EMERALD OAKS SUBDIVISION

APPLICATION NUMBER 9 DATE February 15, 2007

DETAIL SITE PLAN

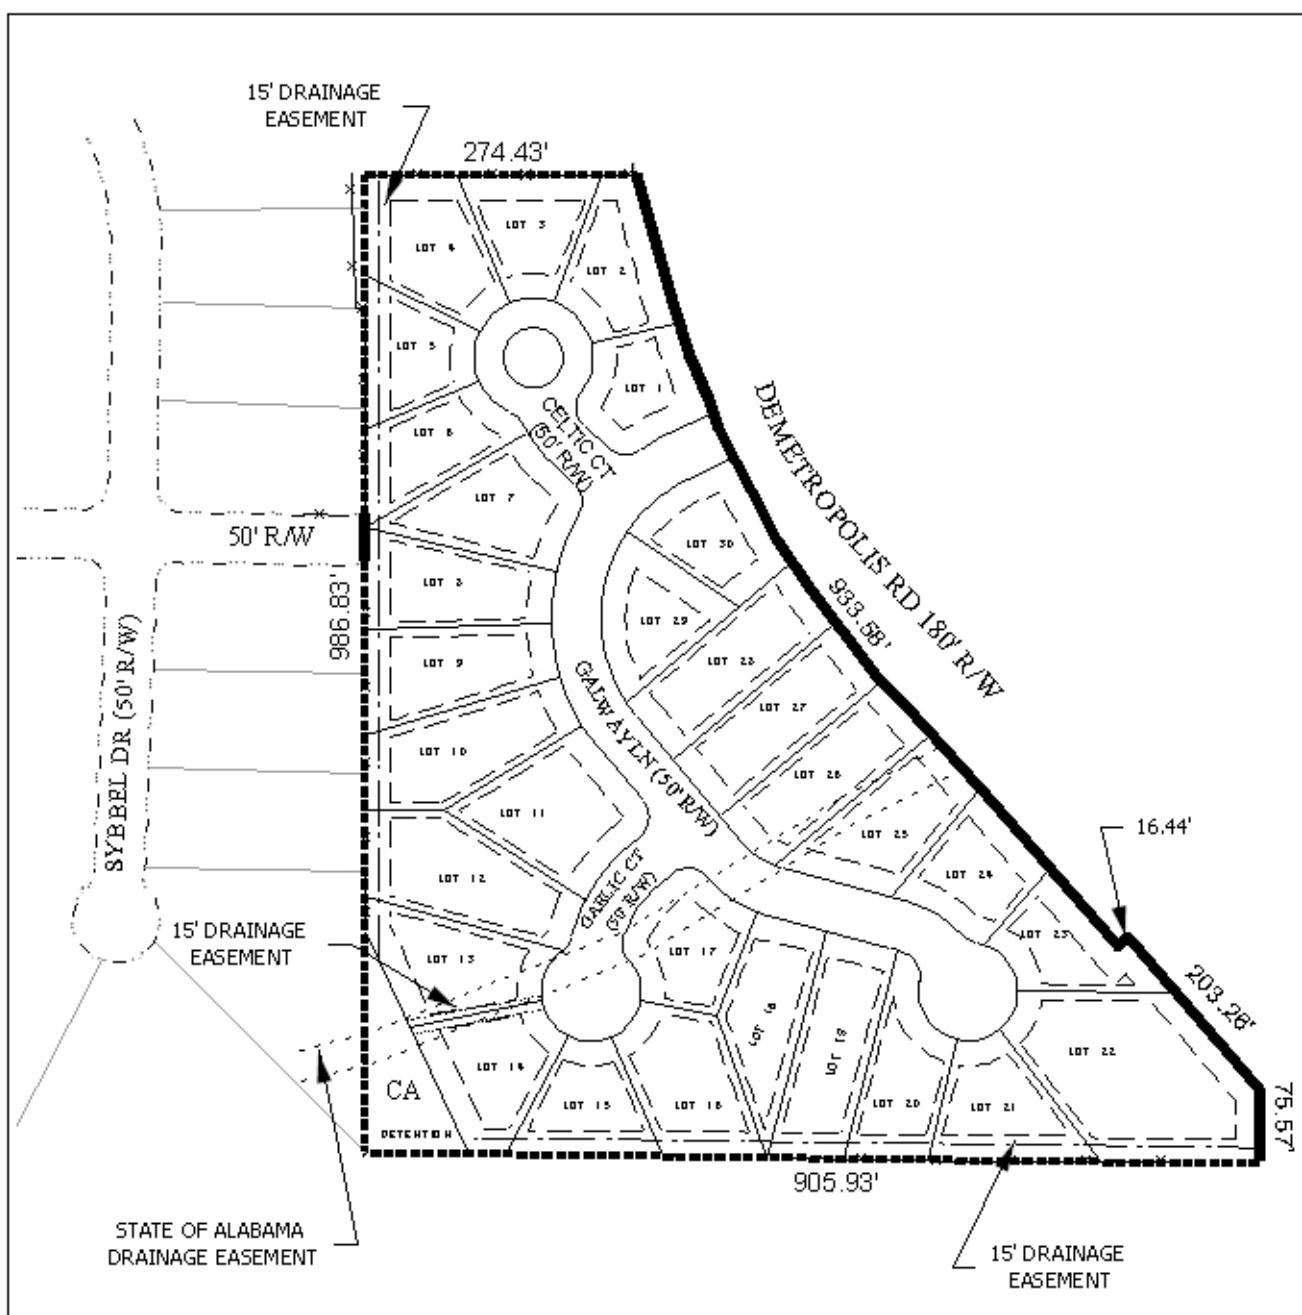
Preservation status is to be given to the 60" Live Oak Tree located on the Common Area of Celtic Court, the 60" Live Oak Tree located on Lot 29, the Live Oak Tree located between Lots 27 and 28, the 70" Live Oak Tree located between Lots 11 and 12, and the 65" Live Oak Tree located between lots 19 and 20. Any work on or under these trees are to be permitted and coordinated with Urban Forestry; removal to be permitted only in the case of disease or impending danger.

The proposal involves the creation of new streets, which must be constructed to City Engineering standards. As the site abuts an existing street-stub to the West, the proposed subdivision should connect with the street-stub, in conformance with Section V.B.1. of the Subdivision Regulations.

Access management is a concern because the site fronts a planned major street. A note should be placed on the plat stating that all lots are denied direct access to Demetropolis Road, and the number, size, design and location of all curb-cuts must be approved by Traffic Engineering and comply with AASHTO standards.

A drainage easement for the State of Alabama, approximately 30 feet in width, cuts across the site. The presence of the drainage easement and the layout of the lots presents a concern relating to the adequacy of building area for four of the proposed lots. It is recommended that the subdivision be redesigned to better accommodate the existing drainage easement across the site, or that the applicant demonstrate that each of the four lots will have adequate buildable area once all setbacks and easements are taken into account.

The plat shows a detention common area near the Southwest corner of the site, with access provided through a drainage and access easement. A note should be placed on the final plat stating that maintenance of the common and detention common areas is the property owners' responsibility.

The 25-foot minimum building setback line is depicted for the lots from all internal streets, but not from Demetropolis Road. The plat should be revised to also depict the minimum building setback line from Demetropolis Road.

Based on the preceding, this application is recommended for Holdover until the March 15th meeting, with revisions due by February 21st, to allow the applicant to undertake the following: 1) revision of the plat to provide a connection to the street-stub to the West in conformance with Section V.B.1. of the Subdivision Regulations; 2) revision of the plat to better accommodate the drainage easement across the site or demonstration that the lots affected by the easement have adequate buildable area as it relates to the easements and all applicable setbacks; and 3) revision of the plat to depict the 25-foot minimum building setback from Demetropolis Road.
